ADMINISTRATIVE AMENDMENT

PROJECT NUMBER: 1004606
APPLICATION NUMBER: 14DRB-70202

DURANGO

Site Plan for Subdivision

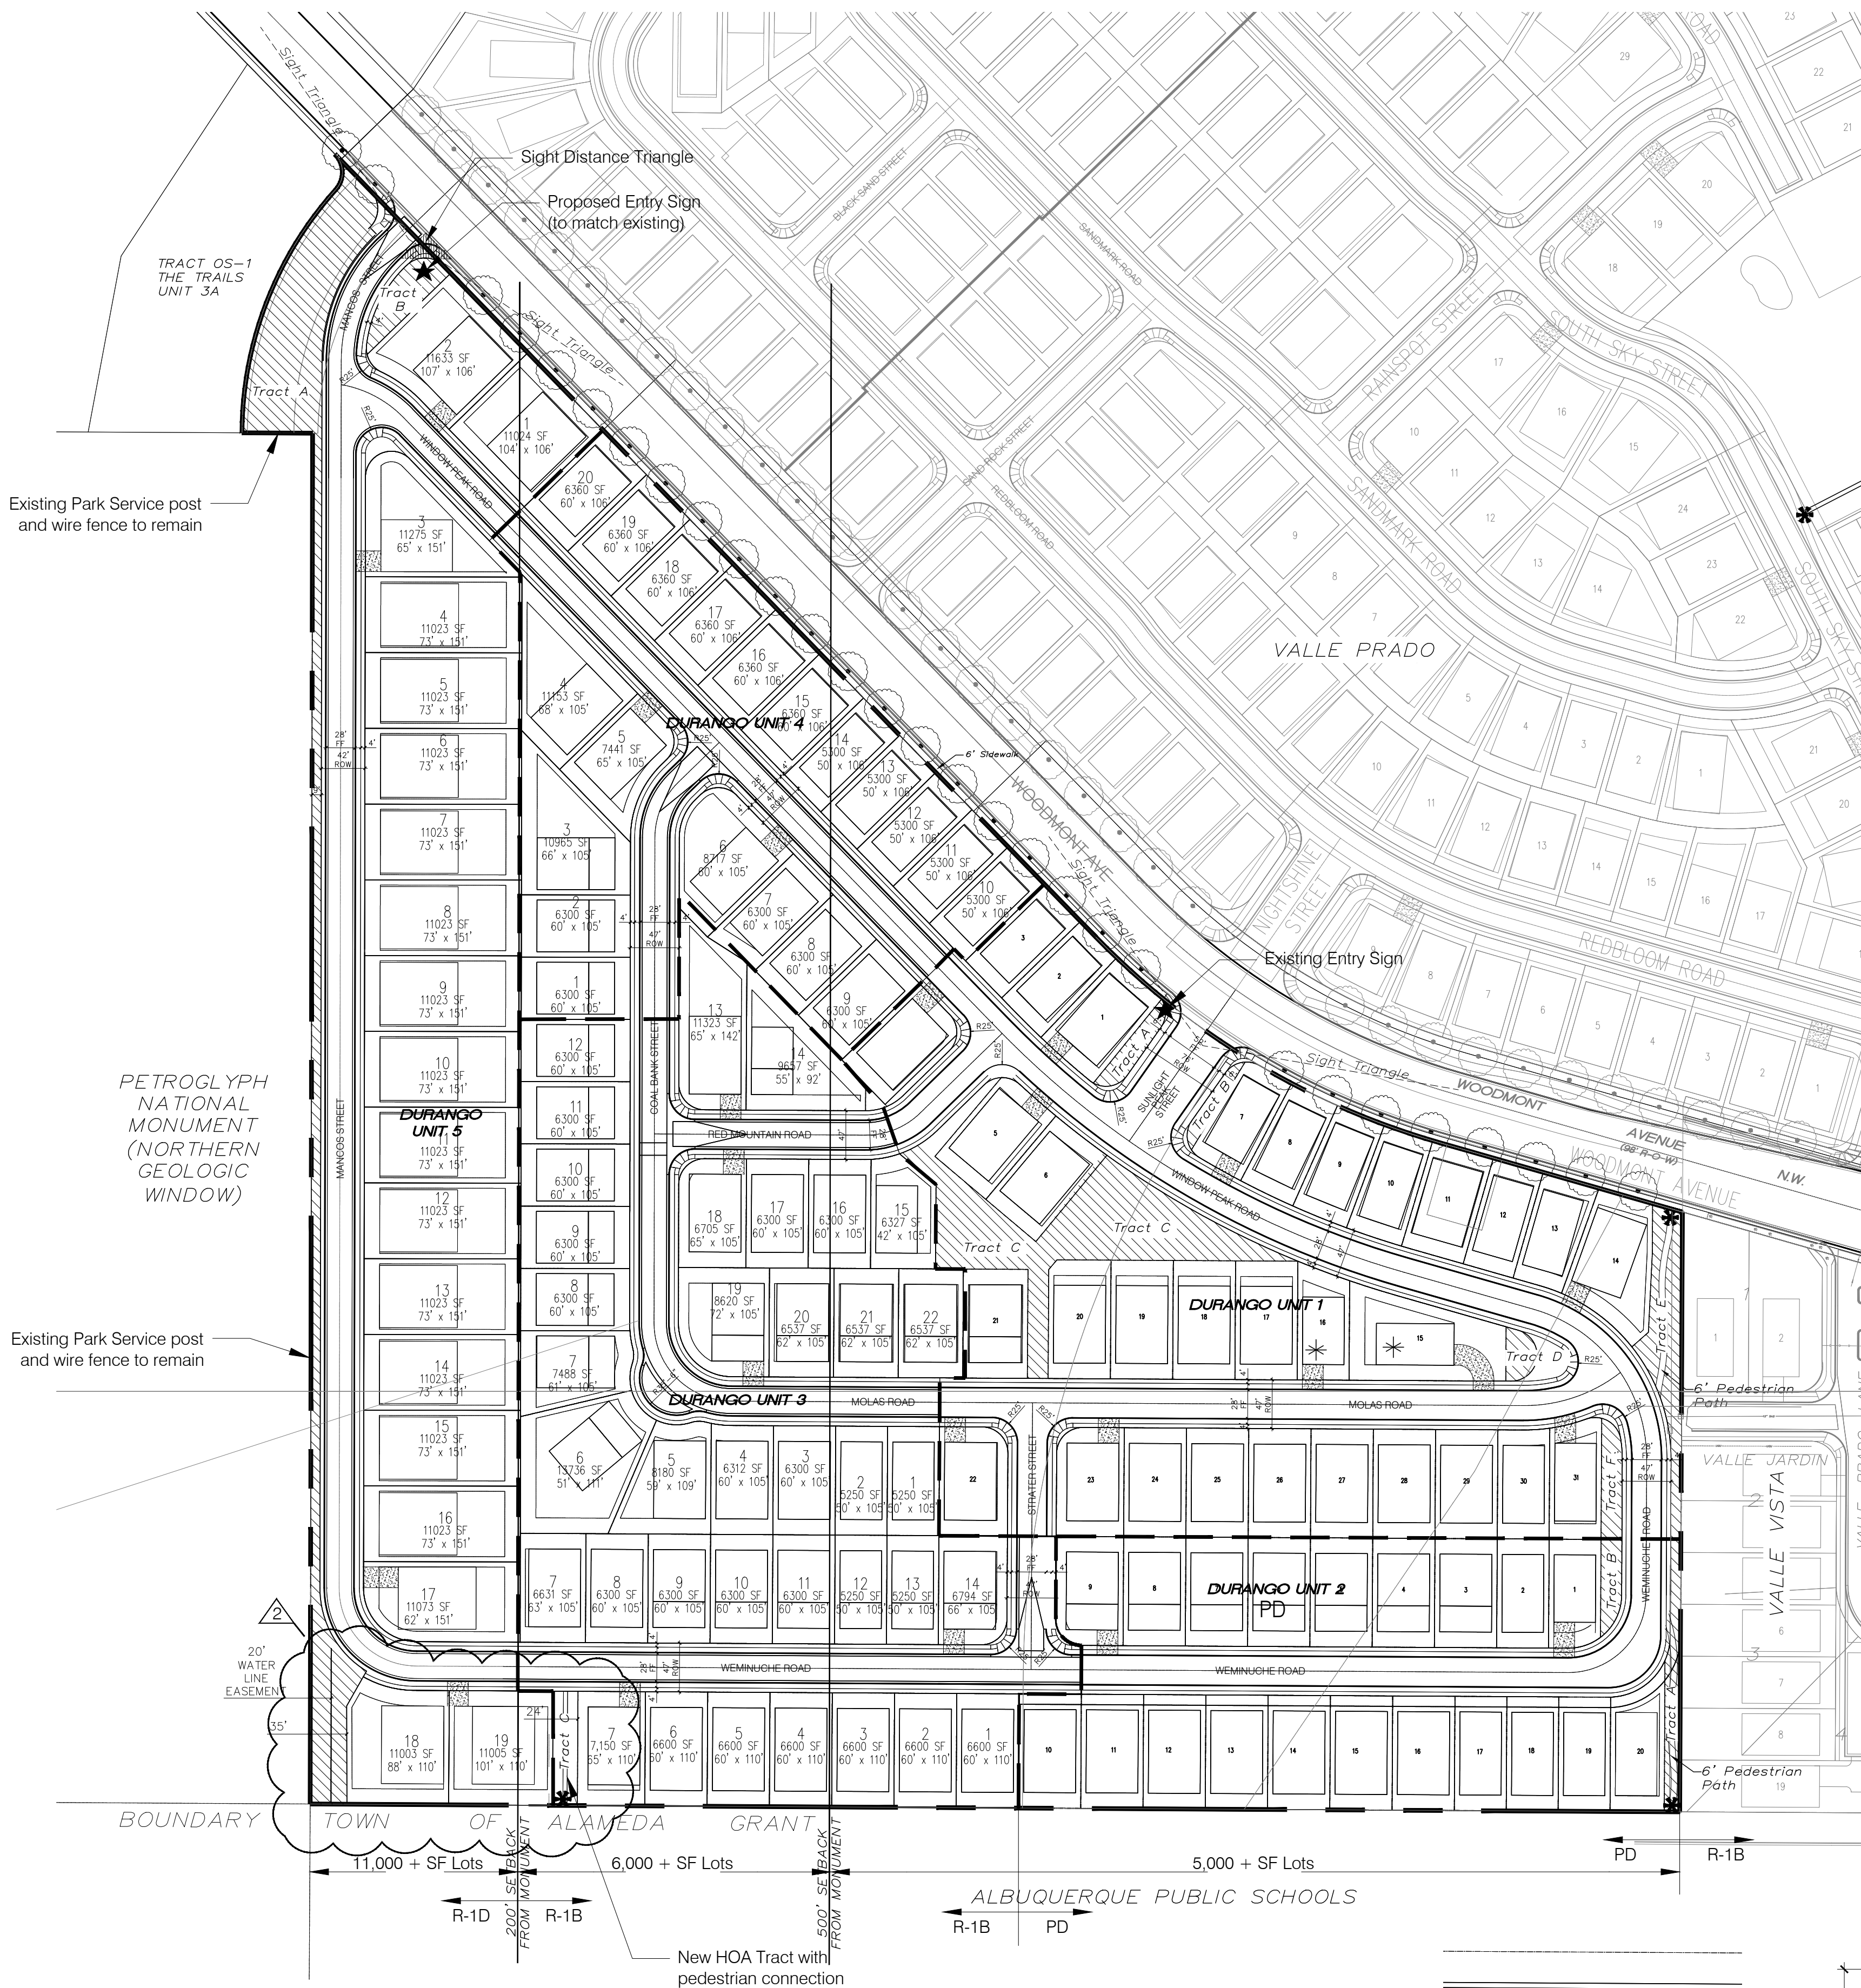
- ELIMINATION OF HILLERMAN STREET CONNECTION TO TIERRA ANTIGUA E.S.
- CREATION OF HOA TRACT WITH PEDESTRIAN CONNECTION TO TIERRA ANTIGUA E.S.
- SHIFT UNIT 5 LOTS 18 AND 19 TO ACCOMMODATE EXCLUSIVE 20' WATERLINE EASEMENT TO ABCWUA.

Site Plan for Subdivision

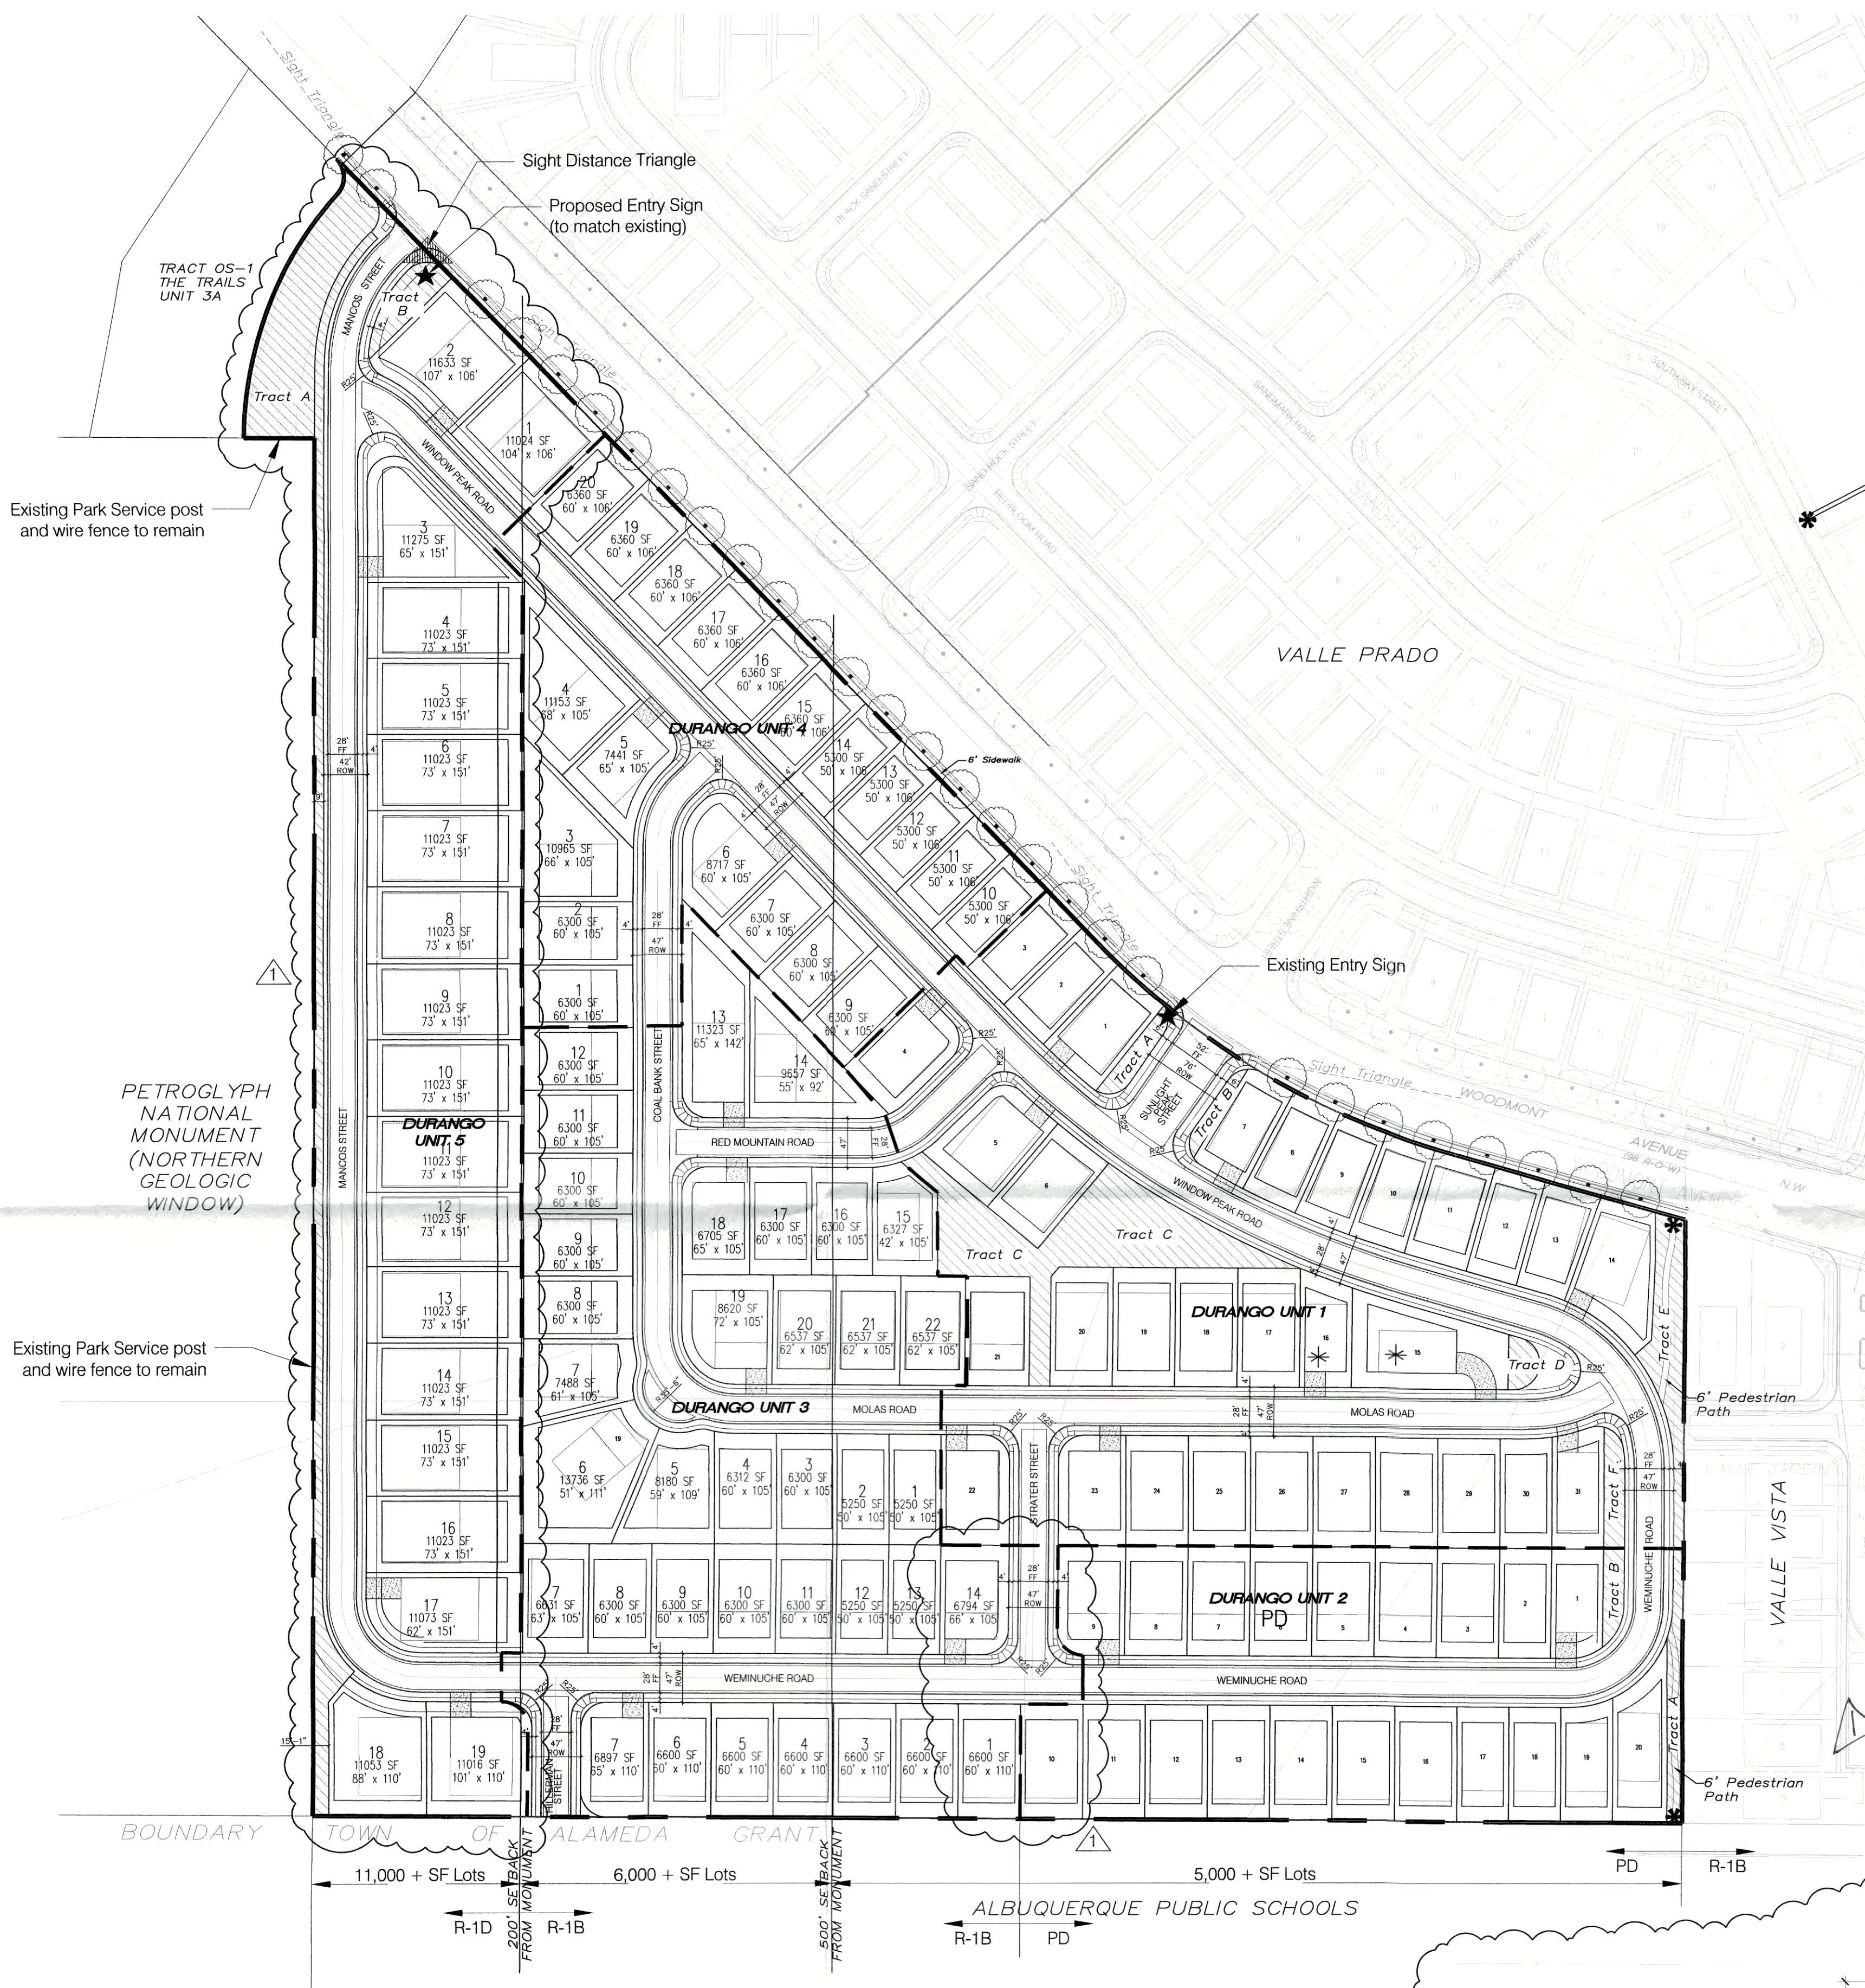
- UPDATED TO THE IDO ZONING (R-1D AND R-1B).
- UPDATED SITE PLAN FOR UNIT 5: 1) ELIMINATED THE 8' PEDESTRIAN PATH, PEDESTRIAN GATE, AND VEHICLE GATE ON THE WEST SIDE OF MANCOS STREET, 2) ELIMINATED EXTENSION OF WINDOW PEAK ROAD WEST OF MANCOS STREET, 3) REDUCED MANCOS STREET ROW FROM 47' TO 42'; 4) CREATED BUFFER BETWEEN MONUMENT AND LOT 18 AT SW CORNER (THERE WAS NO BUFFER ON THE PREVIOUSLY APPROVED PLAN), AND 5) RECONFIGURED HOA TRACTS AS A RESULT OF SITE PLAN CHANGES NOTED ABOVE.
- ADJUSTED BOUNDARY BETWEEN UNITS 2 AND 3, REMOVING 2 LOTS (FORMER LOTS 10 AND 11, DURANGO UNIT 2) FROM UNIT 2 AND PUTTING THEM INTO UNIT 3 (DID NOT CHANGE TOTAL LOT COUNT).
- REMOVED VIEW FENCE DETAIL.
- ADDED TYPICAL MONUMENT SIGN ELEVATION.
- CONFIRM SETBACKS FOR ALL UNITS AS FOLLOWS:
 - FRONT: 15 FEET
 - REAR: 15 FEET
 - SIDE: 5 FEET (CORNER LOT: 10 FEET)
